ISSUE: Permit to Demolish/Capsulate (partial) and Certificate of Appropriateness for alterations

APPLICANT: 732 and 806 Development LLC

LOCATION: Old and Historic Alexandria District
732 North Washington Street

**BAR2026-00055 - OHAD**
732 North Washington Street

Figure 1: Previous (left) and revised (right) view showing proposed balconies

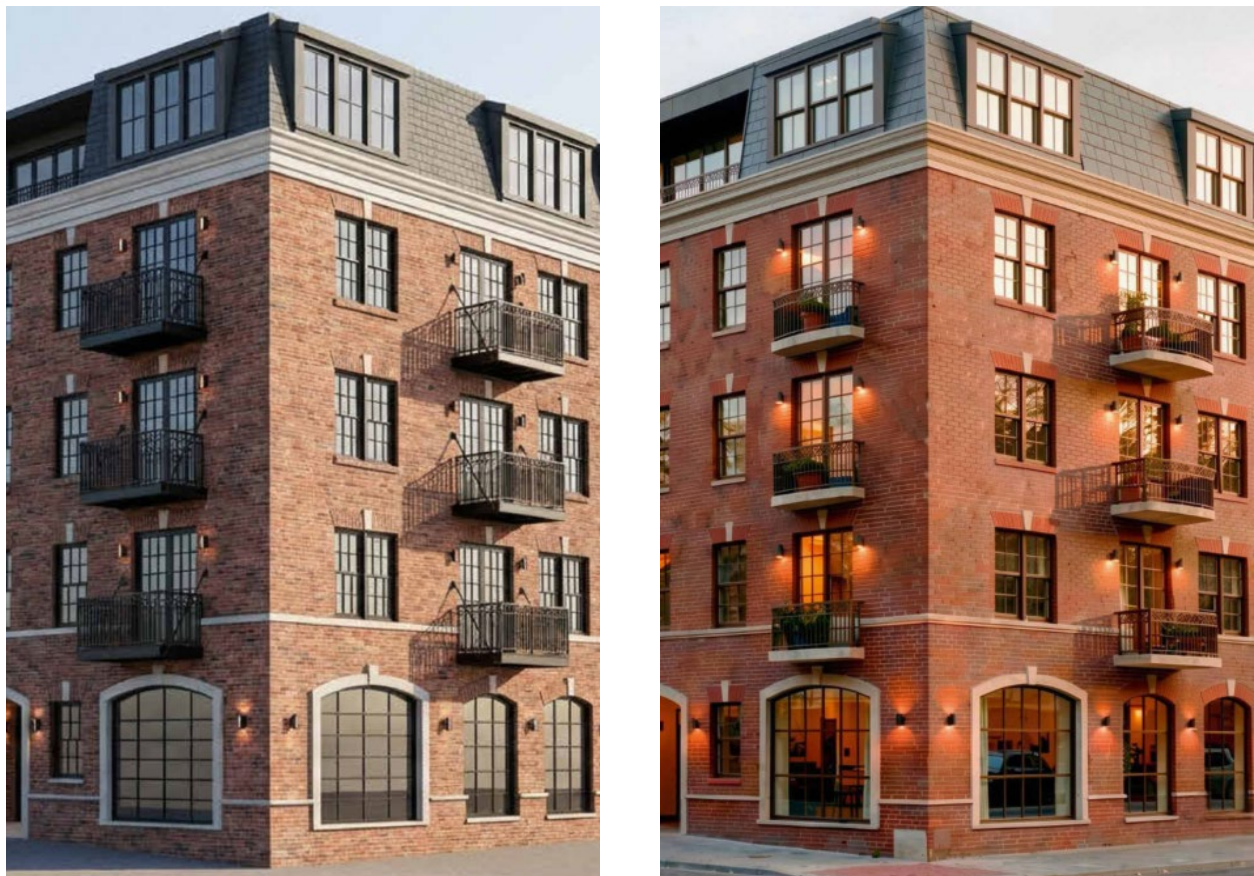
Board members expressed concern that the proposed balconies are not integrated into the design of the building and that the ones on the east side of the building did not reflect the more formal nature of the buildings facing N Washington Street. In the previous design, the balconies were metal with metal tiebacks and had a rectangular footprint. In the revised design, the applicant is proposing solid balconies that are curved and do not include turnbuckles (Figure 1). On the Washington Street elevation, the balconies have been reduced in size to become Juliette balconies.

The revisions to the proposed balconies are in response to concerns that the previous version was not integrated into the design of the building and not appropriate for a building facing Washington Street. All of the balconies now feature a solid concrete base in lieu of the previous metal and dispense with the wall mounted tie-backs. The shape of the balconies has also been changed to feature a curved front with a curved metal railing that is reminiscent of the curved masonry openings at the ground floor. The balconies on the Washington Street facing elevation have been converted into Juliette balconies with a minimal projection from the face of the building. These types of balconies are more formal in nature and reflect the character of buildings with their primary facades facing Washington Street. The balconies facing Madison Street project further from the face of the building, reinforcing this as a secondary elevation. Staff finds that the revisions

to the proposed balconies are consistent with the design of the building and maintain the “memorial character” of Washington Street as noted in the Washington Street standards.

Figure 2: Previous (top) and revised (bottom) east elevation of the fifth floor

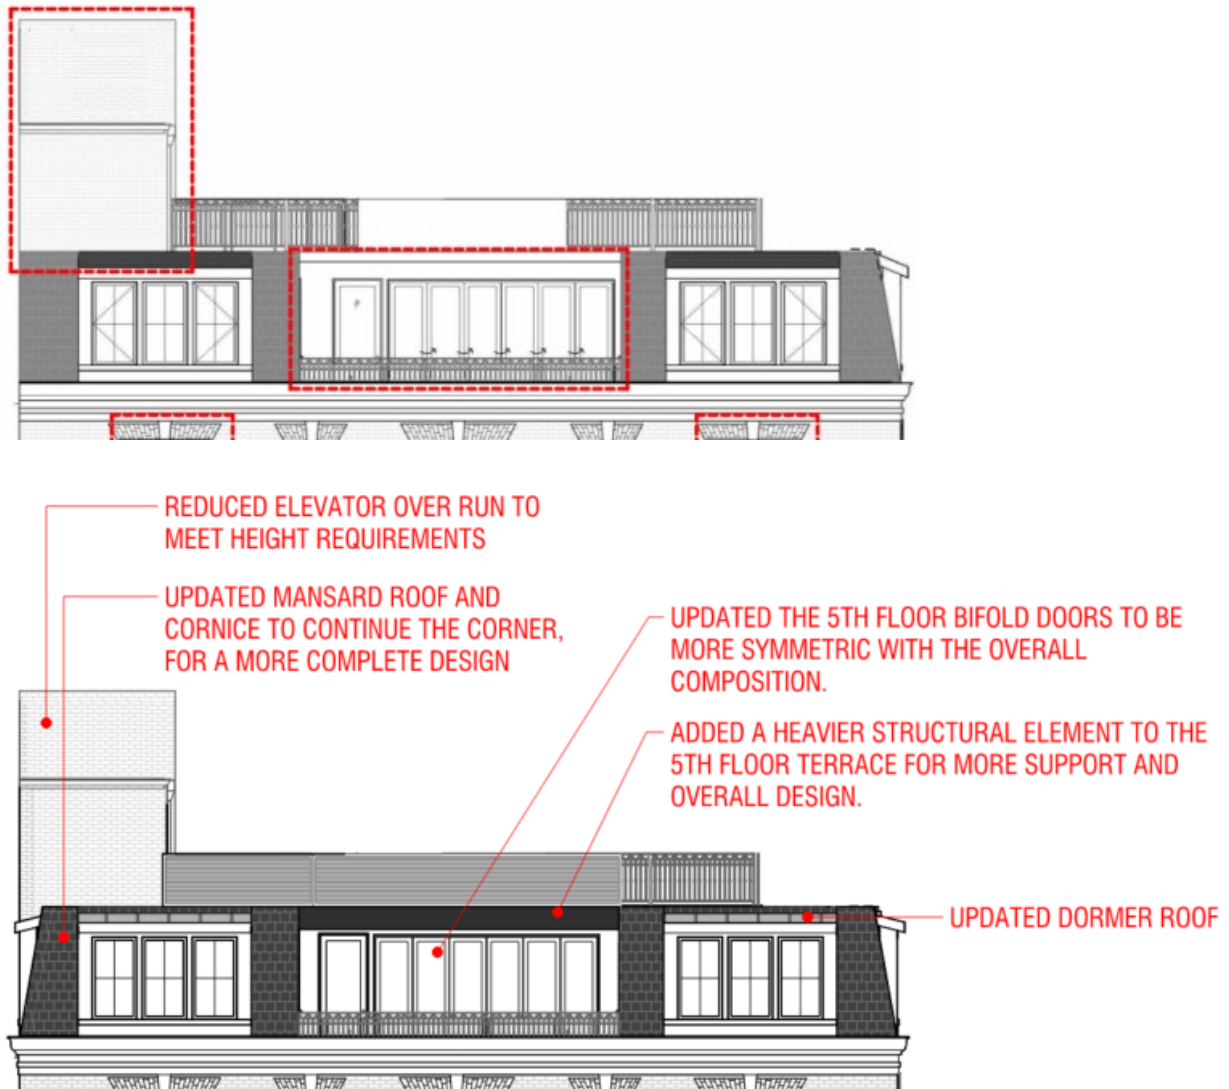
The applicant is proposing to replace the existing metal clad mansard roof with a new simulation slate clad mansard roof with dormers and recessed balconies. During the previous Certificate of Appropriateness review, Board members expressed concern regarding the configuration of the dormers, the roof of the recessed balconies, and the extent of the sloped mansard. In response to these comments, the applicant has made several revisions to the design (Figures 2-4). The sloped mansard now extends around the south east corner of the building and along the south edge until it intersects the vertical roof structure. At each of the recessed balconies, the applicant is now including a beam at the edge of the roof to provide visual weight to this overhang. The dormers have been shifted and simplified to better align with the window bays below, this occurs mainly at the north and west elevations. In addition to changes to the mansard roof, the brick clad elevator overrun has been lowered based on elevator equipment requirements.

The proposed design includes the demolition of the existing metal clad mansard roof and the construction of a new fifth floor that includes a mansard roof with dormers and recessed balconies. The Board supported the replacement of the existing mansard with the proposed design but asked the applicant for refinements to make the design consistent with the historic fabric. In the revised design the applicant has reconfigured the dormers so that they align with windows below and create a ratio of roof to dormer that is more similar to historic buildings. The recessed balconies help to break up the massing of the fifth floor and reduce the overall visual weight. Some Board members were concerned that the roof of these balconies appeared to be insignificant in relation to the distance being spanned. In the revised design, the applicant has added a deep beam to the edge of this roof giving a visual weight to this edge. The submission materials include an option for these recessed balconies that includes two midspan columns. Staff finds that these columns disrupt the horizontal proportions of the fifth floor and suggests that the applicant move forward with the option that includes only the beam at the edge of the roof. As noted during the previous hearing, the sloped section of the mansard roof stopped at the south east corner of the building with the southern edge of the roof as a vertical surface. This belied the understanding of the mansard roof as a three dimensional object providing a top to the building. In the revised design the sloped mansard roof now extends along the southern edge of the building and includes dormers on this elevation. The effect of this is to portray the fifth floor as an integral part of the building design. The proposed modifications to the design for the fifth floor address comments from the Board and create an element that is consistent with the historic context and the character of Washington Street.

REAR ELEVATION : PUBLIC ALLEY

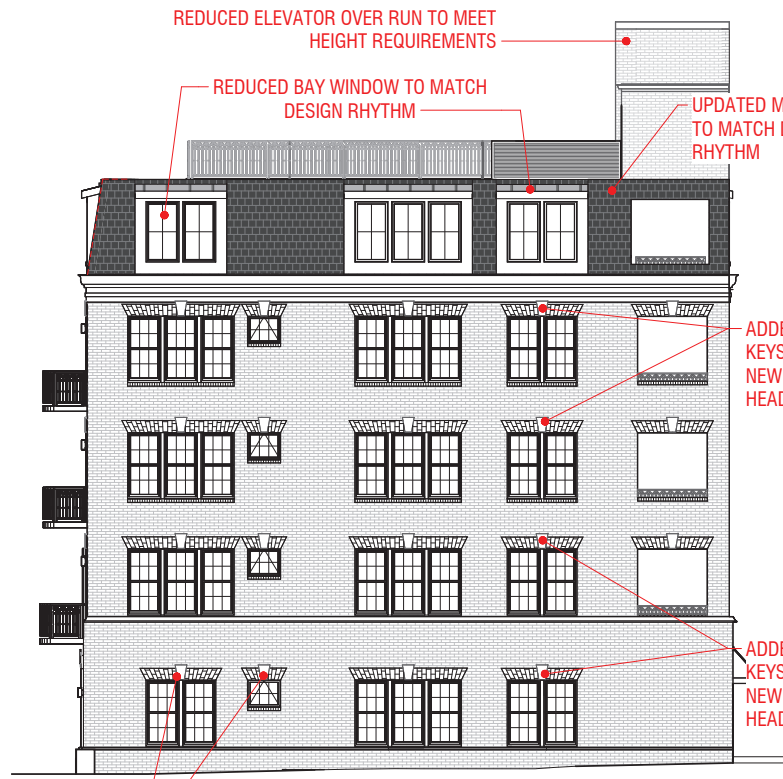
The applicant has modified the design for the west elevation to be more similar in terms of level of detail, to the east and north elevations. Previously, the windows in this area did not include the same keystones and the dormers were not aligned with the windows below. In the revised design, the windows have a similar level of trim to those on the other elevations and the dormers have been modified to be smaller and to align with the elevation below (Figure 5).

ADDED NEW KEYSTONES TO ALL BRICK ARCH HEADERS AT REAR
